S E R V I C E N O T E

OmniBER 37718 / 37719 Comms Performance Analyzer**Build Code Status 3:30 and below**

The following modification is recommended to eliminate potential overheating and premature failure of DS_n DS1 Drop (Demux) Port driver.

Figure 1. Location of Components.

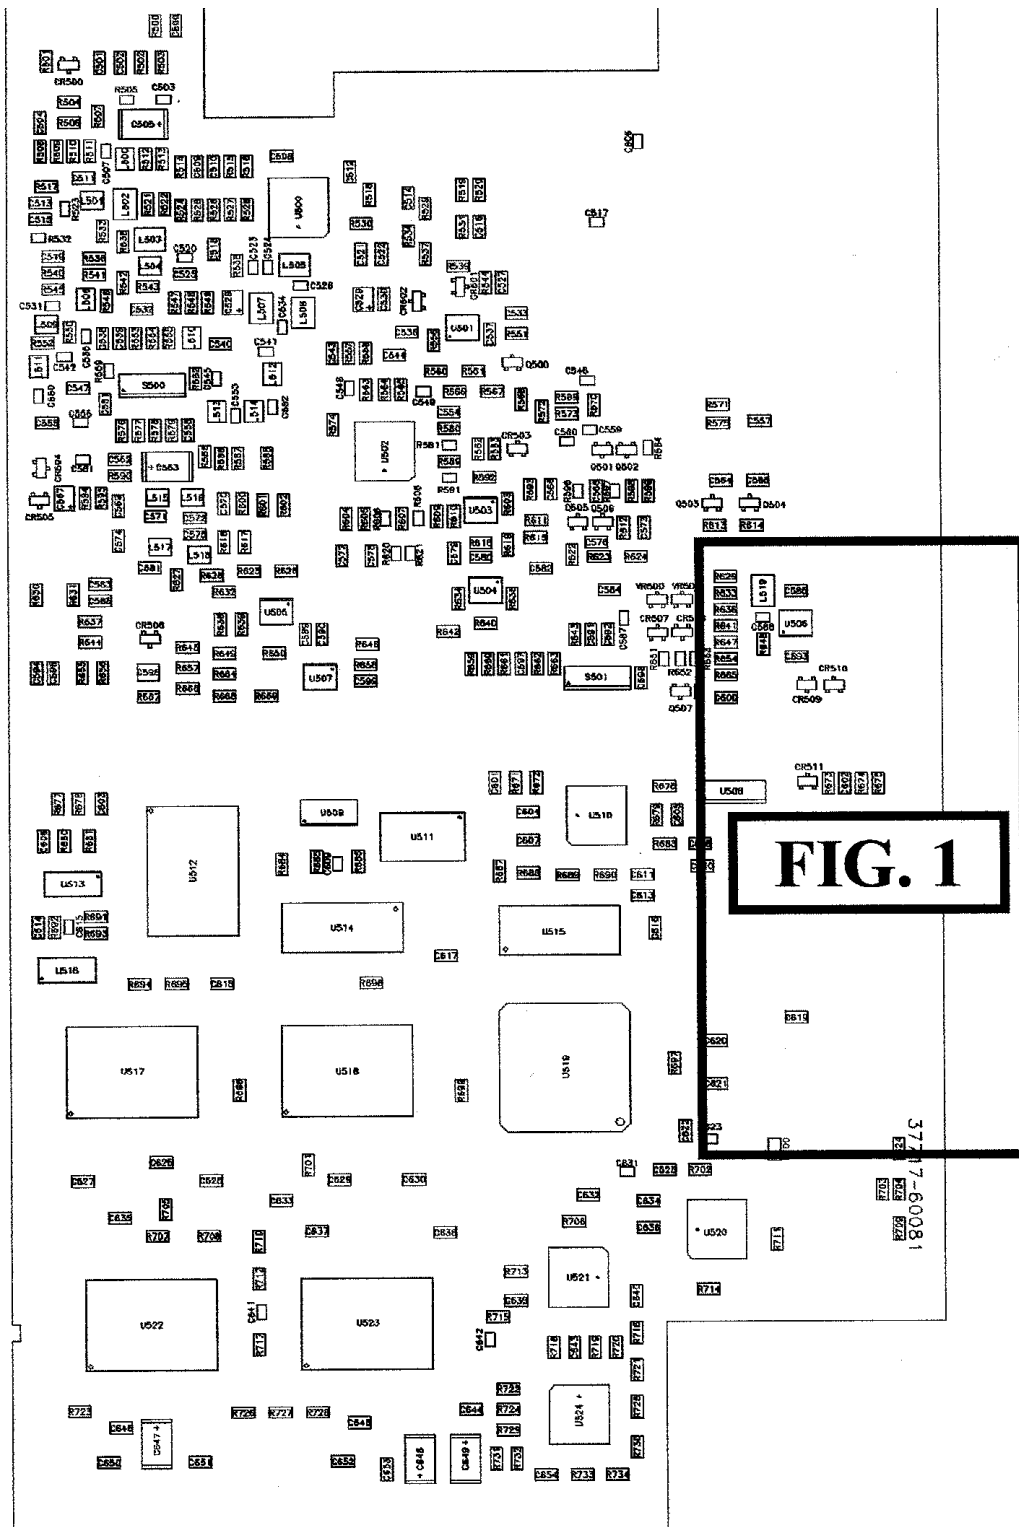
2. Note: Only perform this step if DS_n Drop Port is defective. Remove/replace U505 (PN 1820-8942) taking note of orientation.
3. Solder a 10k ohm resistor Ra (0699-1391) to rh pin of TP8.
4. Solder a 10k ohm resistor Rb (0699-1391) to rh pin of TP8.
5. Add a wire link from vacant end of Ra to U506 pin 1 using insulated wire (see Figures 1 and 2).
6. Add a wire link from vacant end of Rb to U506 pin 7 using insulated wire (see Figures 1 and 2).
